PLANNING & ZONING CASE NO. SP2025-033

PROJECT NUMBER: SP2025-033
PROJECT NAME: Site Plan for 102 West Bourn Street
SITE ADDRESS/LOCATIONS: 102 West Bourn Street, Rockwall, TX, 75087

CASE CAPTION: Discuss and consider a request by Dub Doupbrate of Doupbrate & Associates, Inc. on behalf of Kim Timpa for the approval of a Site Plan for an Office Building on a 1.1308-acre parcel of land identified as Lot 1, Block B, Jack Canup Addition, City of Rockwall, Rockwall County, Texas, zoned Planned Development District 62 (PD-62) for General Retail (GR) District land uses, addressed as 906 S. Goliad Street [SH-205], and take any action necessary.

TO: Planning and Zoning Commission
DATE: September 30, 2025
APPLICANT: Dub Douphrate; *Douphrate and Associates*
CASE NUMBER: SP2025-033; *Site Plan for Timpa Law Office*

FLOOR PLAN

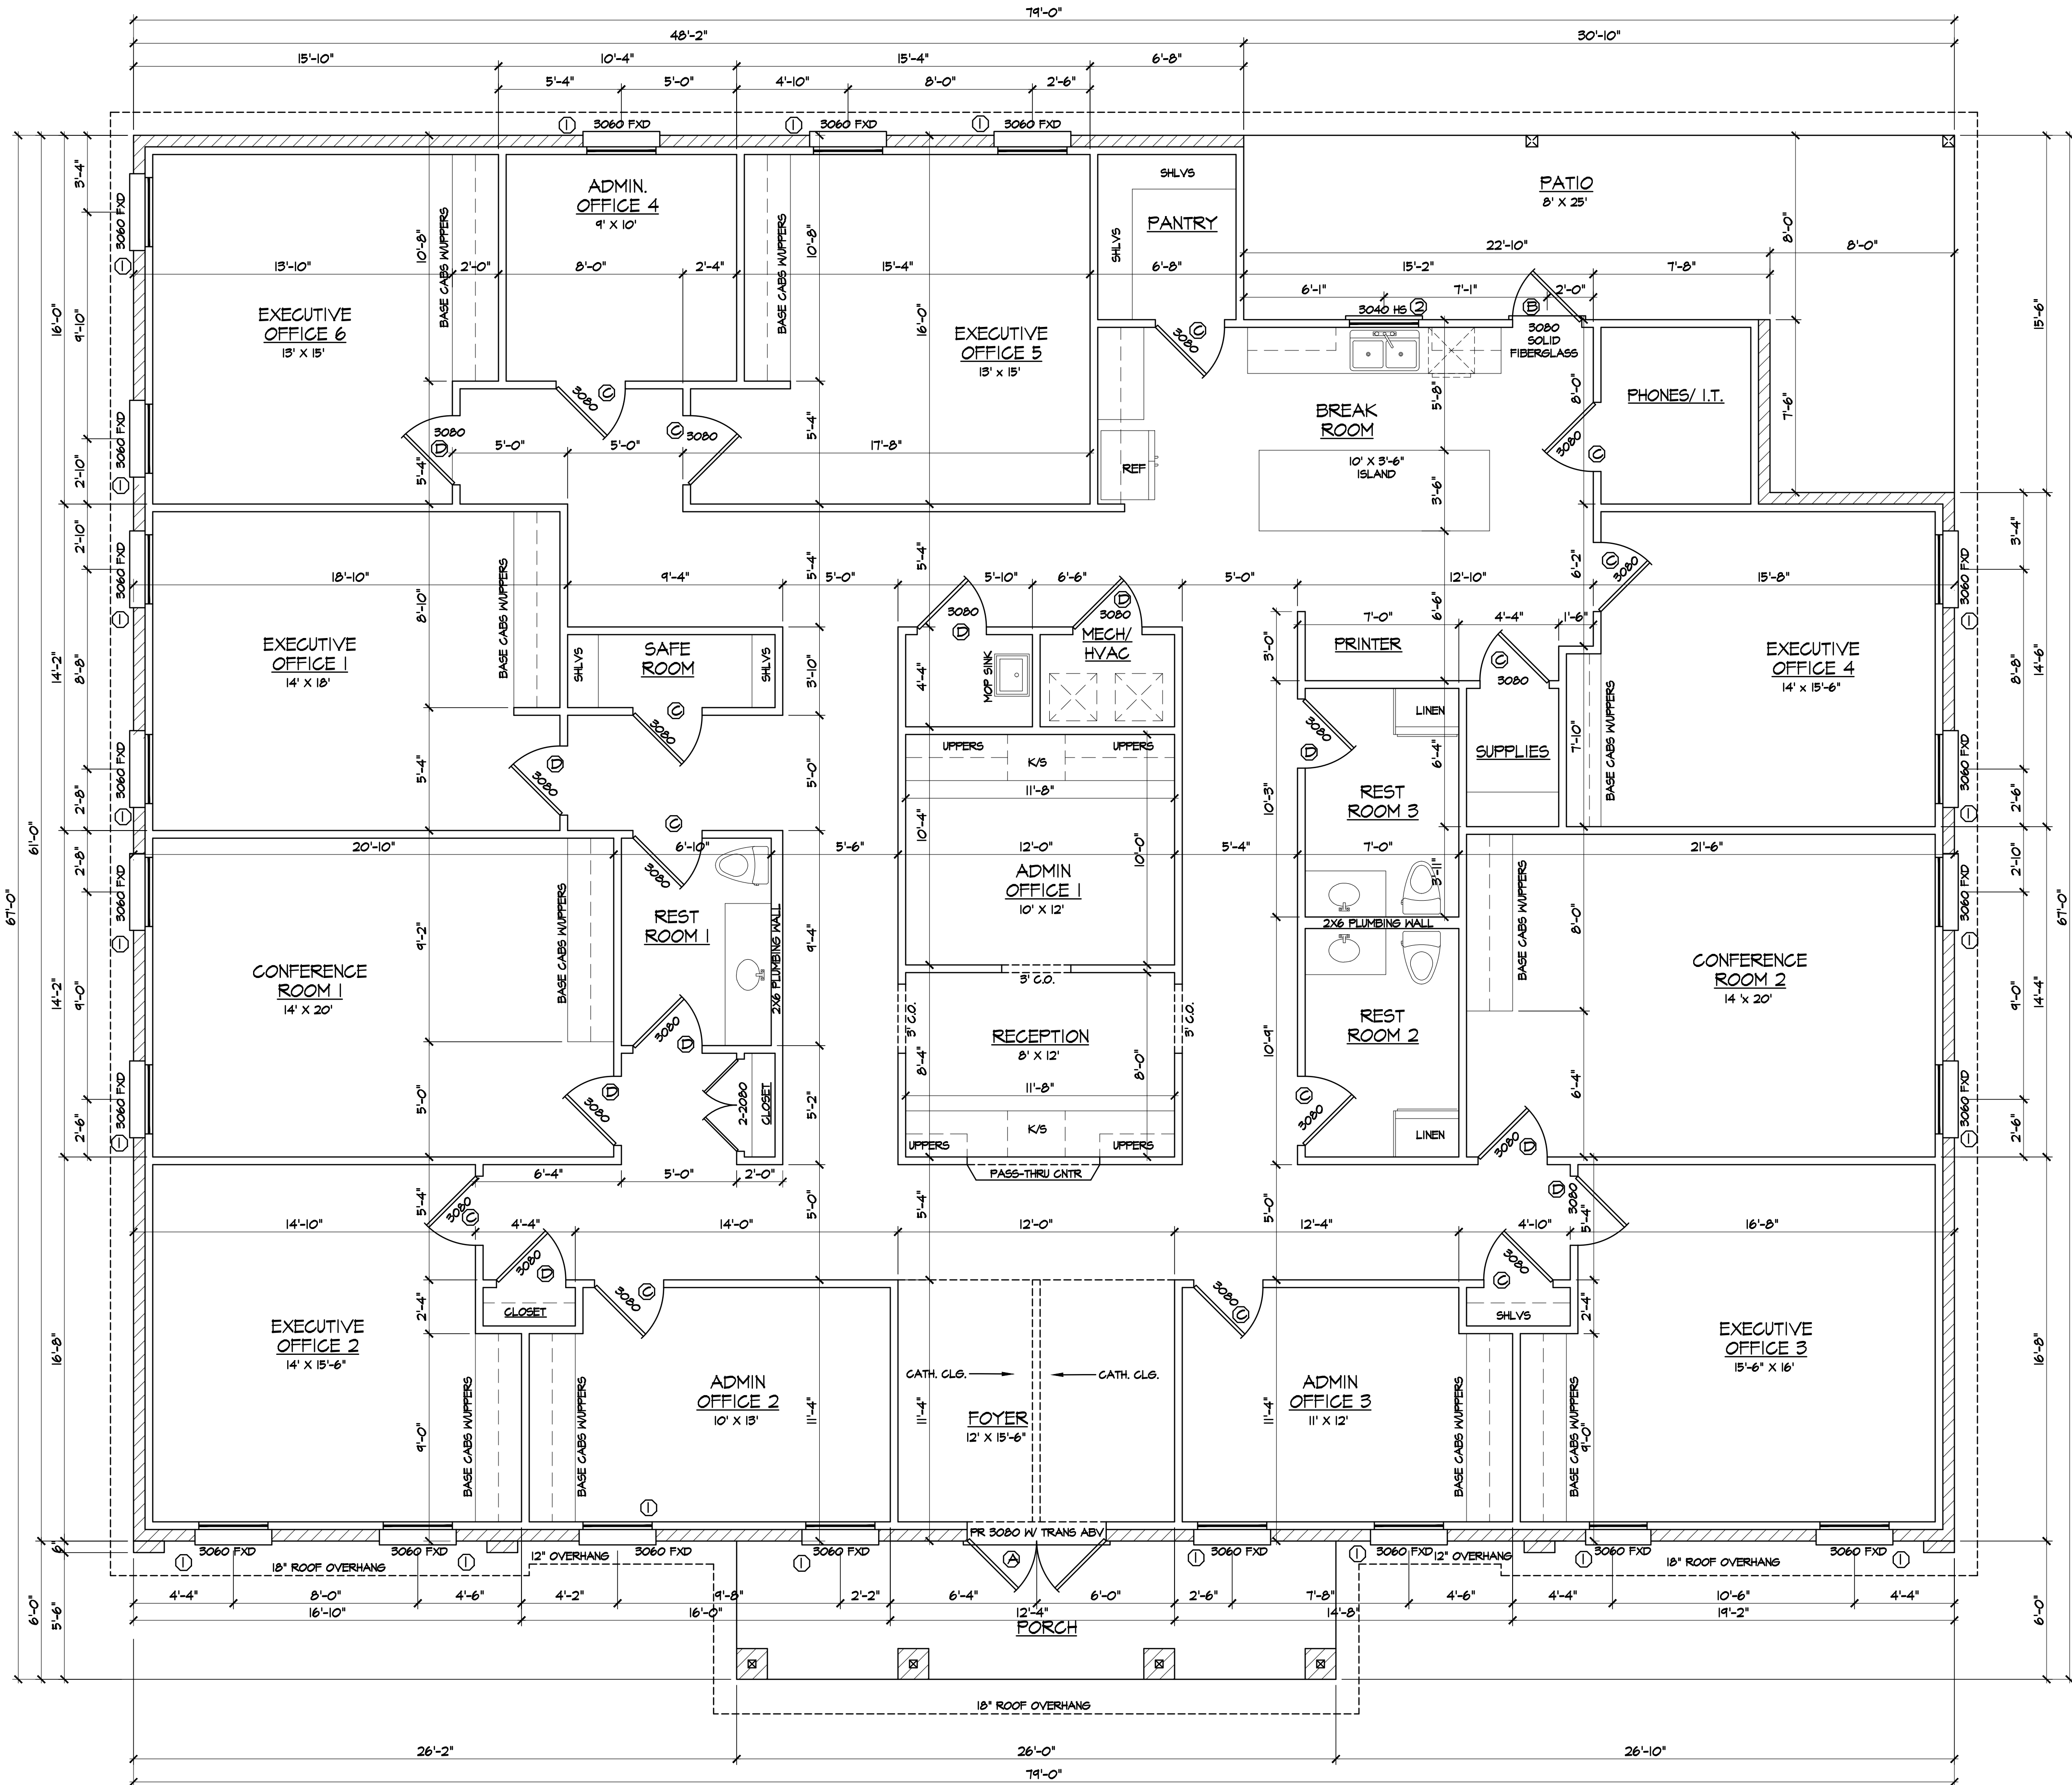
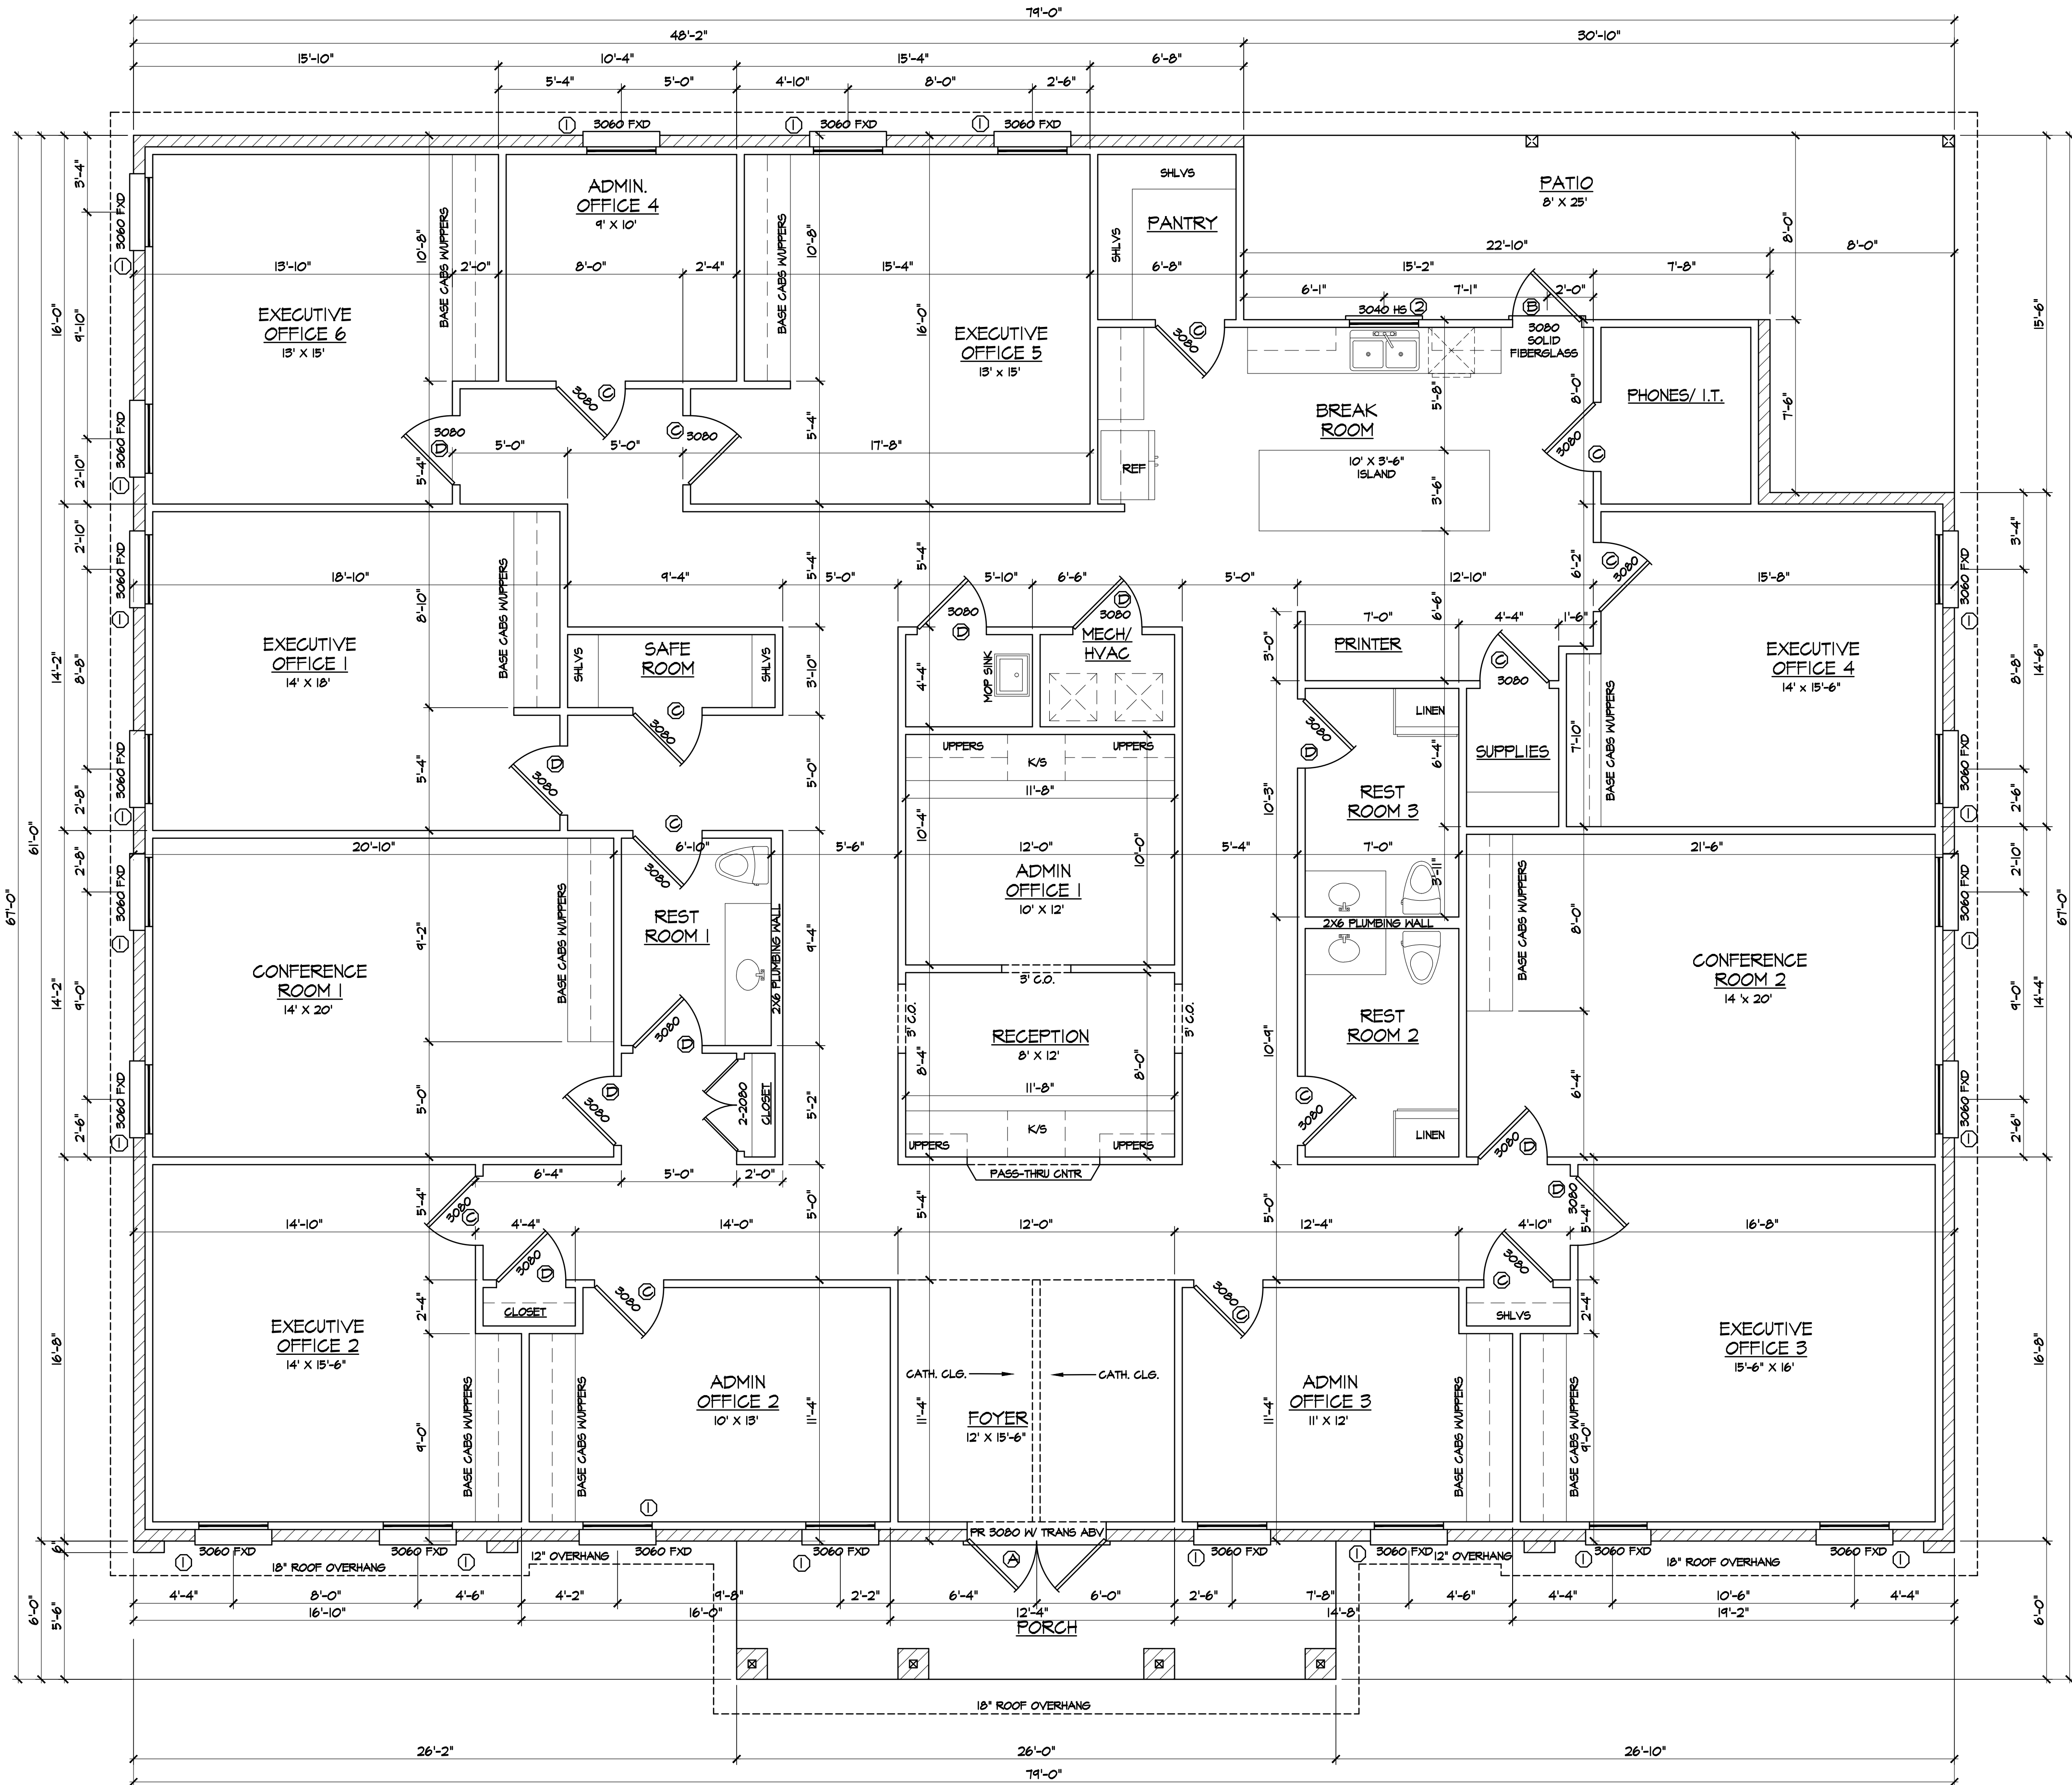
DEPARTMENT	REVIEWER	DATE OF REVIEW	STATUS OF PROJECT
BUILDING	Craig Foshee	08/21/2025	Approved
08/21/2025: DOES NOT APPROVE THE INTERIOR PLAN
